MORGAN / HARBOUR
CONSTRUCTION

**Re: 703-723 W. Algonquin Rd – PUD Amendment – Amendment to PUD Ordinance 18-014 PC#20-016
– Round 2**

The following is our Planning Commission response Letter addressing the comments as outlined in the Village of Arlington Heights Building & Life Safety Department Interoffice Memorandum regarding the aforementioned project:

NORTHWEST TRUCK MAINTENANCE PERSPECTIVE

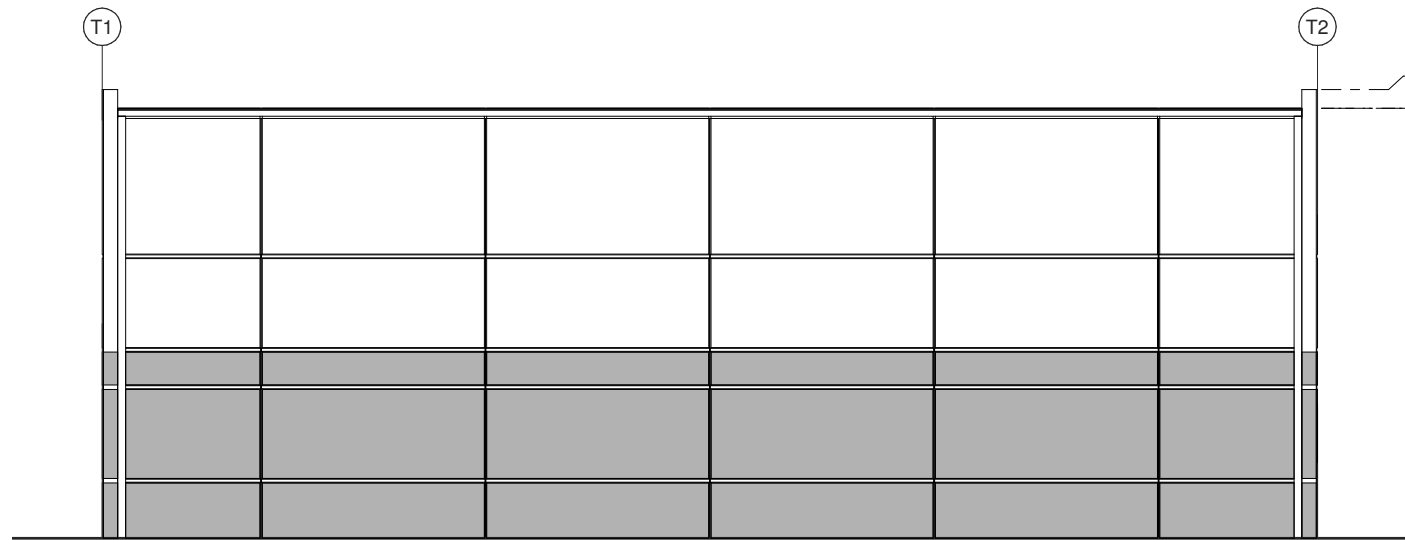
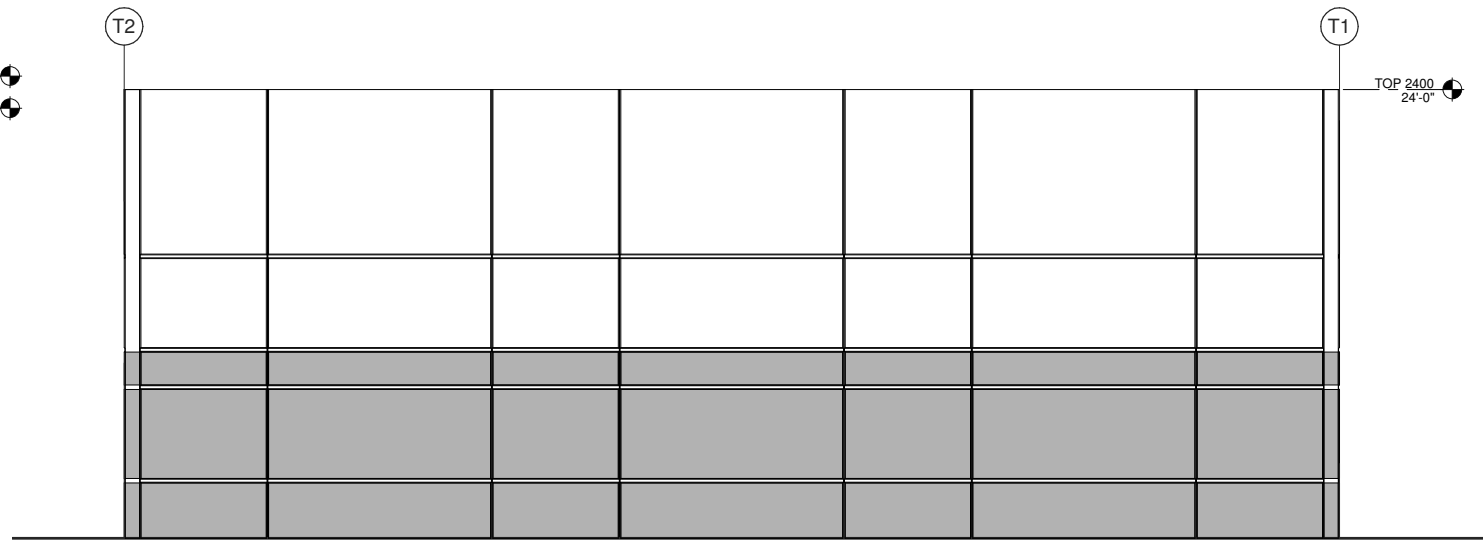
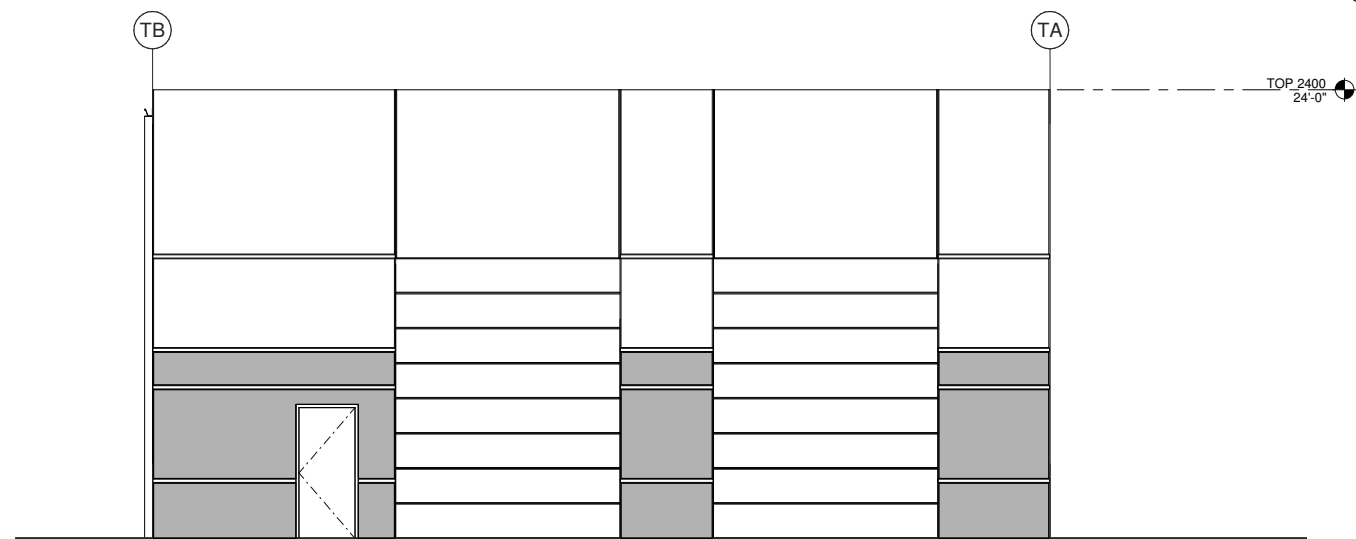
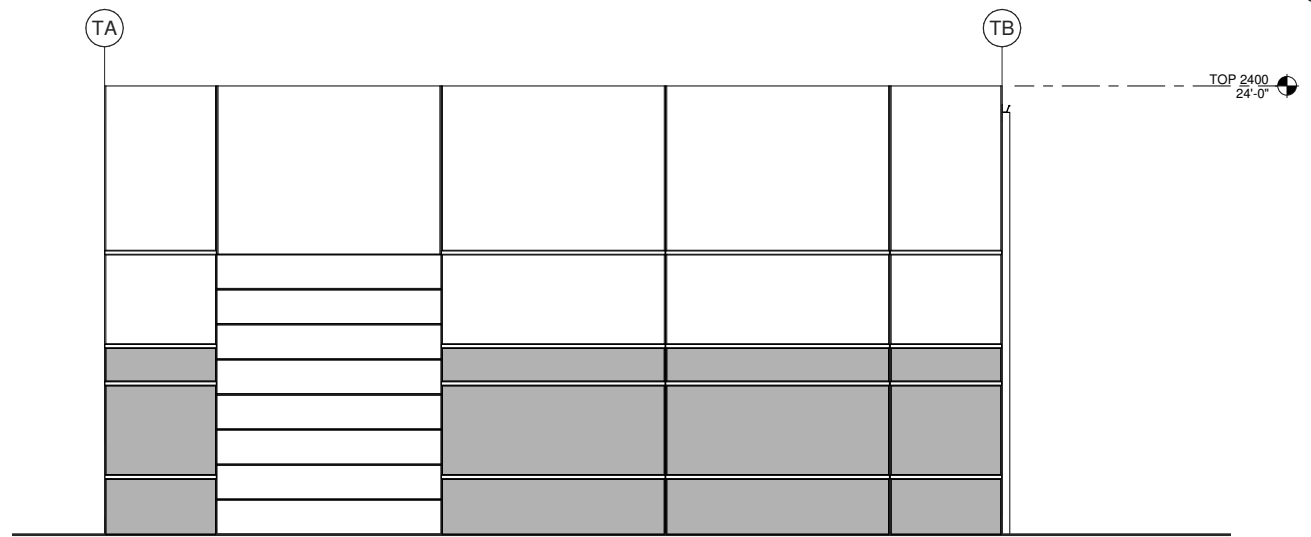
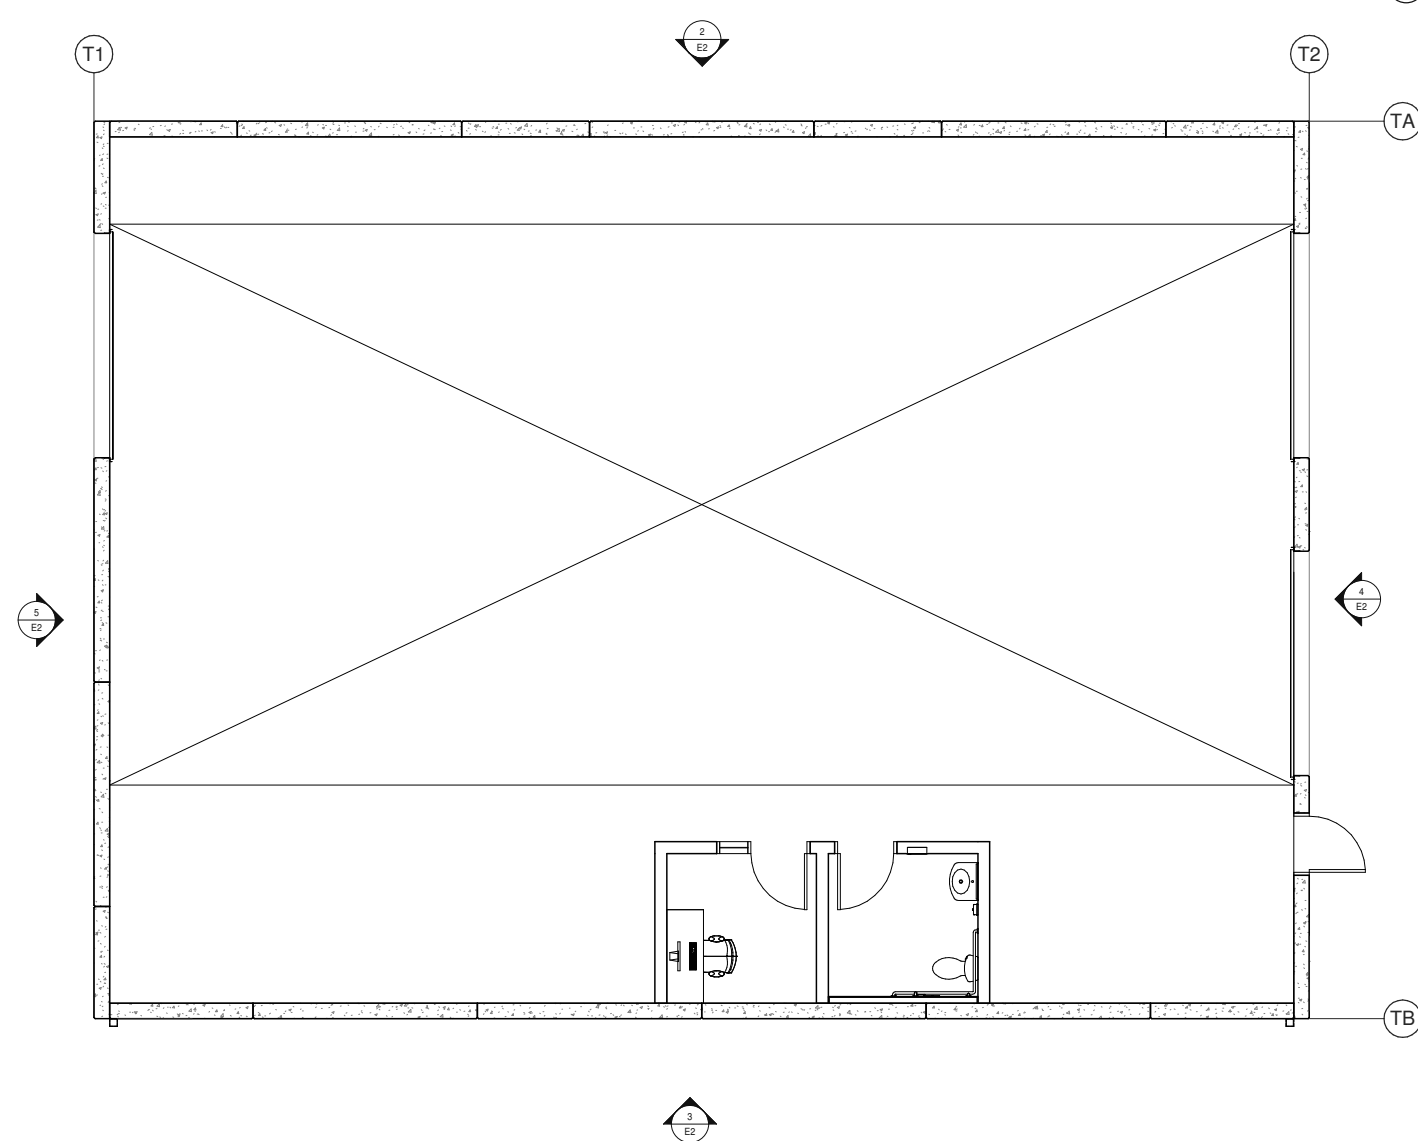
24. **Response:** Updated architectural site plan is included (Exhibit F) as well as drawings that show the revised maintenance building size and elevations. In addition, please see the responses to 21 d and e with regard to the variances.

SCALE: NA JOB #: —
DATE: 10-21-2020 HEC Drawing #: —
DRAFTER: MT ENGINEER: —
SE-101

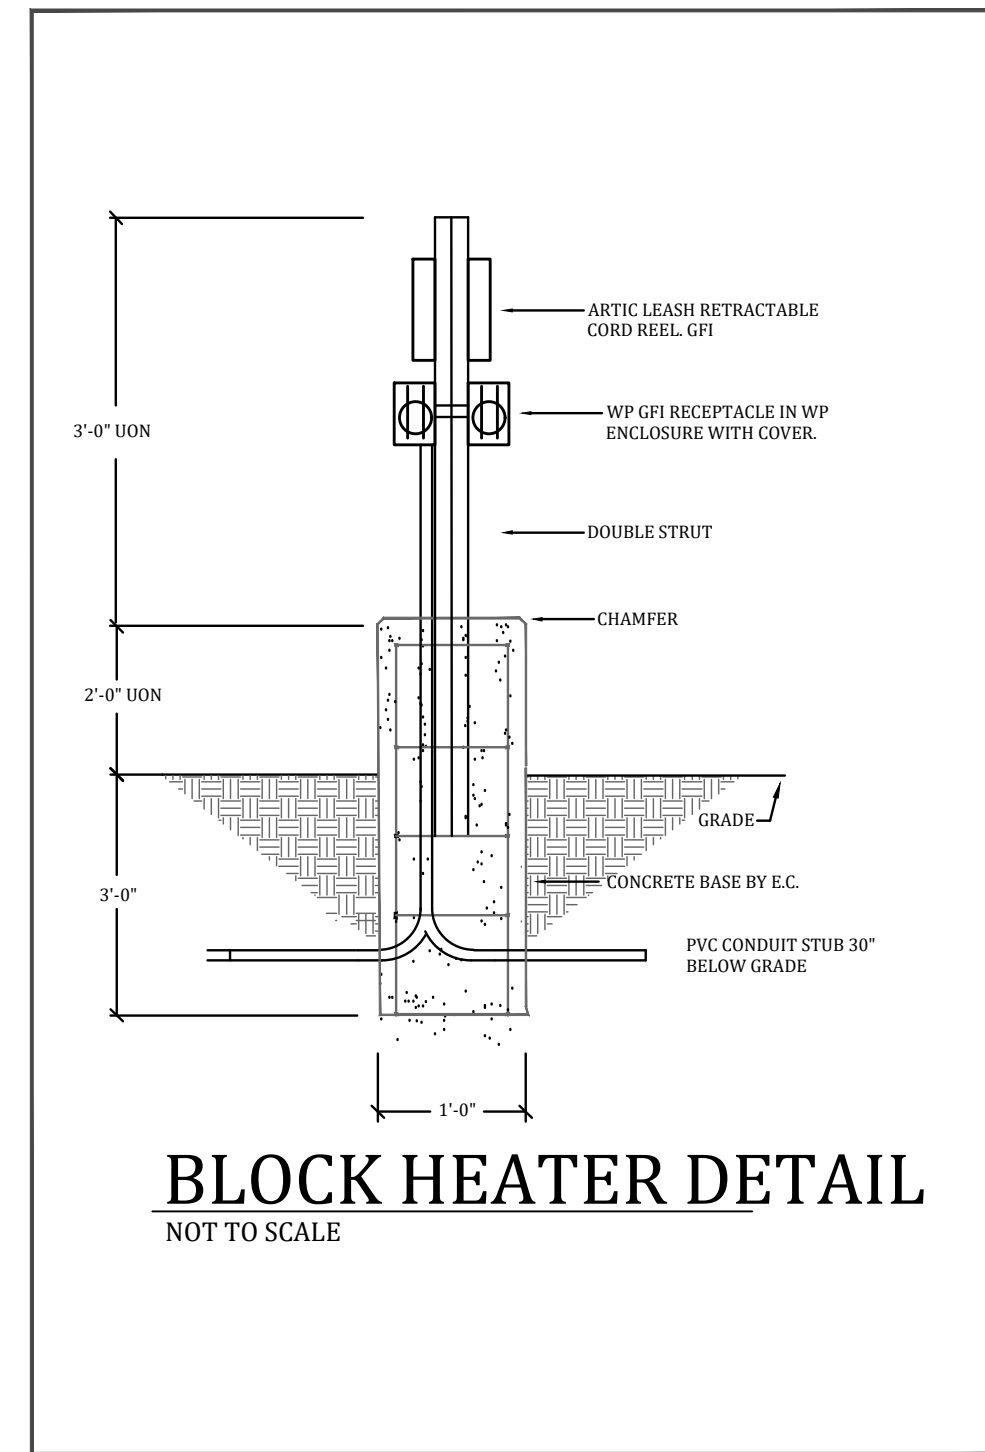
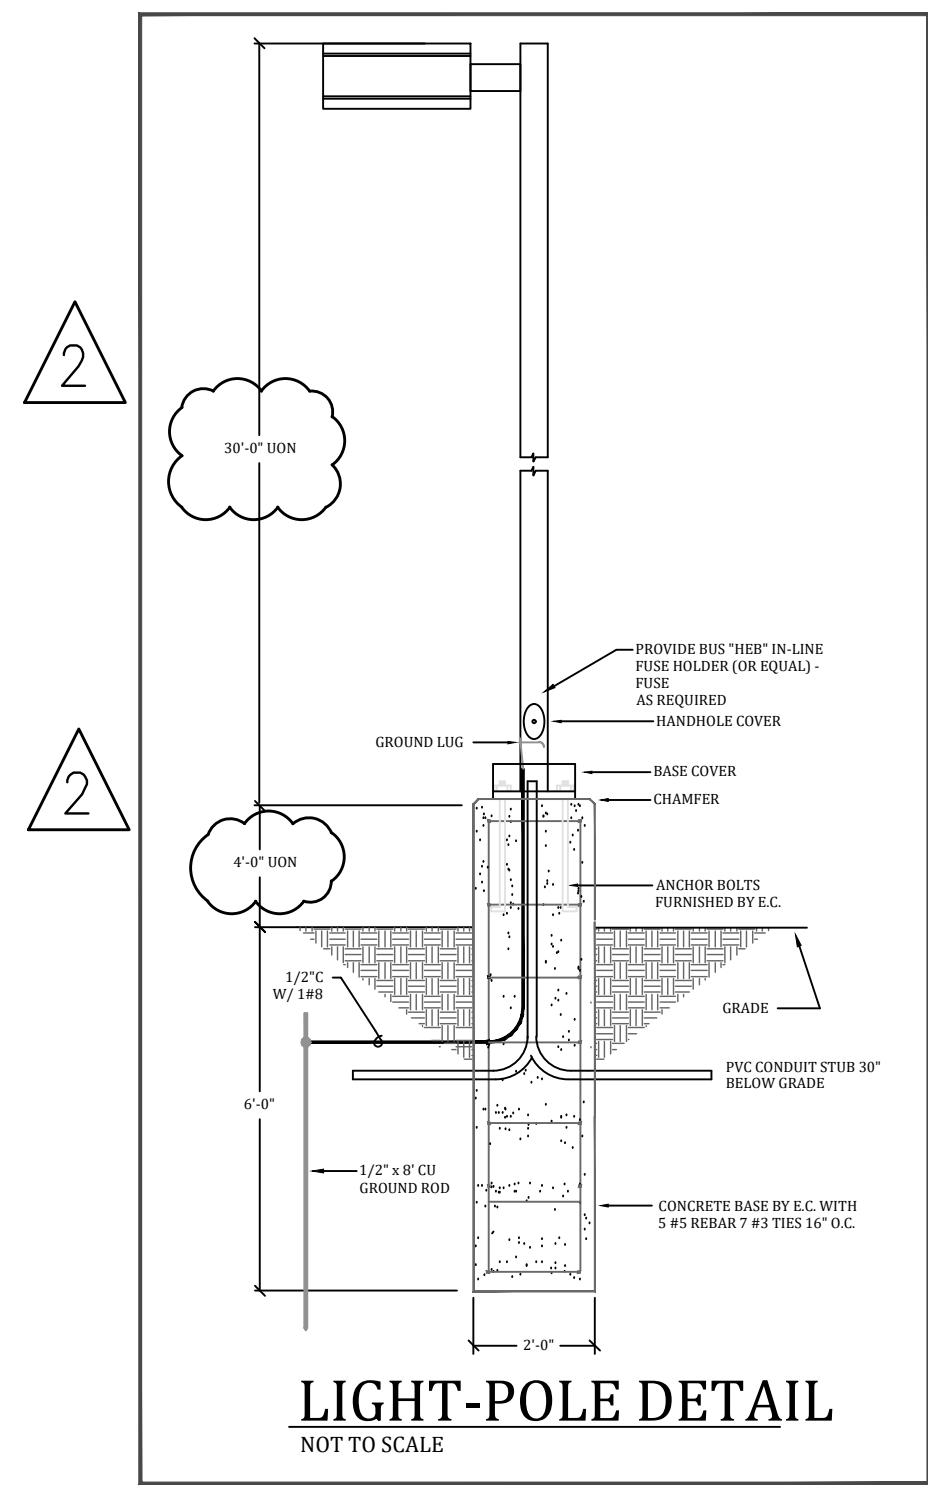
27. **Response:** Light pole detail on sheet SE-101 (Exhibit G) revised to reflect 30' tall poles on 4' tall bases. Changes were clouded. All site lighting poles and bases are to be the same height. Photometrics were ran at this height.
